Countries: Document ID: IK2200161  
Availability: ISIS, FleetISIS, NotSIR Revision: 0  
Major System: BUS BODY Created: 3/27/2025  
Current Language: English Last Modified: 3/28/2025  
Other Languages: NONE Author: Aaron Aguilera  
Viewed: 10

Title: Next Gen Bus AC Bracket Interference with Stepwell Heater Hose

Applies To: Next Gen Bus

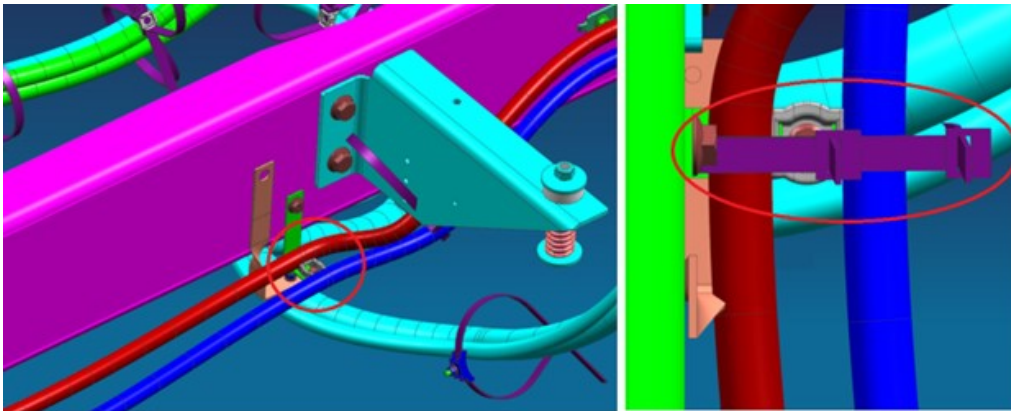
Interference has been discovered between the stepwell heater hoses and the AC twist bracket. This document will guide technicians through an alternative method of fastening the heater hose to the AC bracket that will eliminate contact between the hoses and bracket.

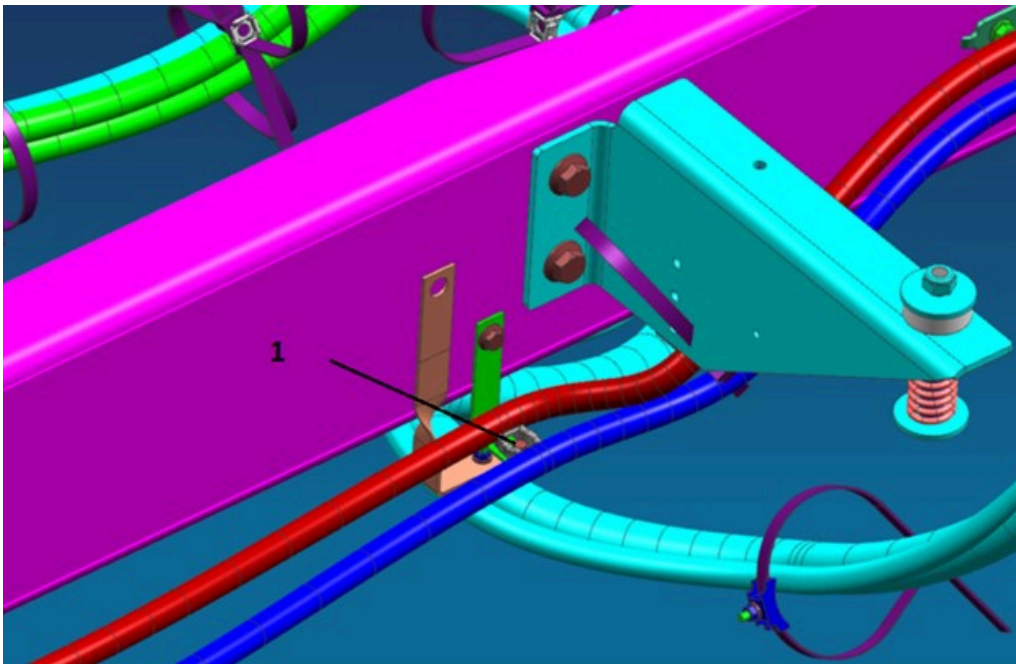
1. Cut cable locks from hose bracket shown below.

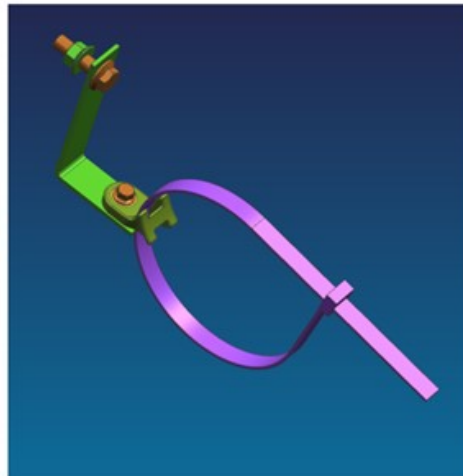
2. Remove the bolt (1) holding the saddle bracket to frame bracket (shown below). Keep the removed fastener, as it will be reused.

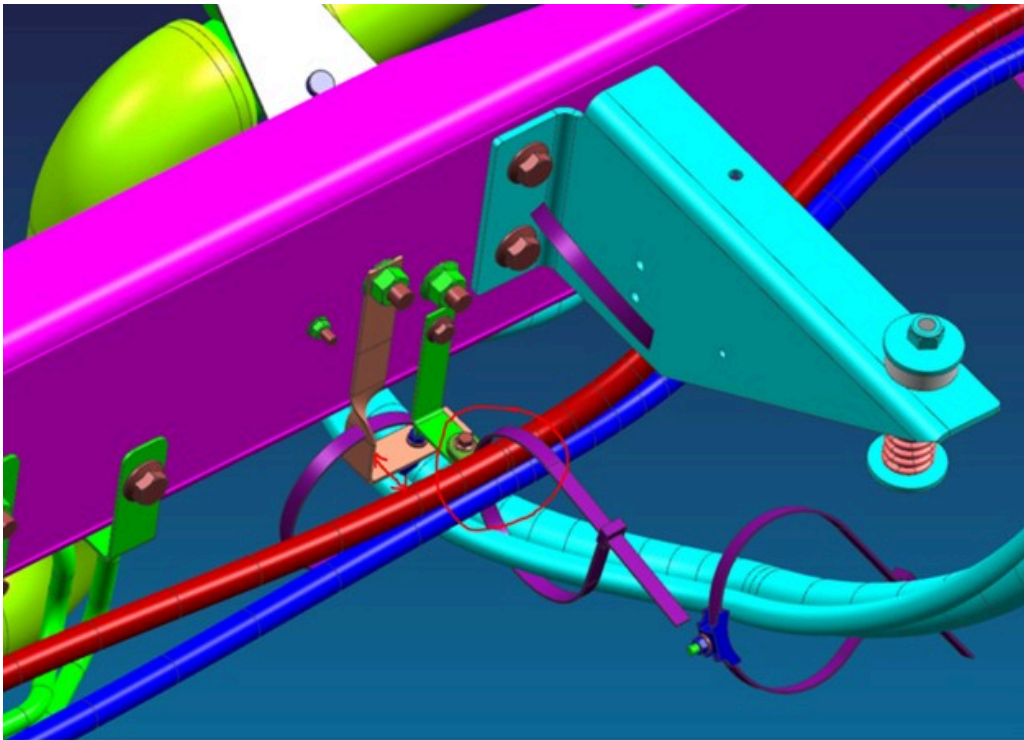
3. Replace the removed saddle bracket with pn: 3821016C1 shown on the right below; torque fastener to 41-50 lb-ft (56-68 Nm).
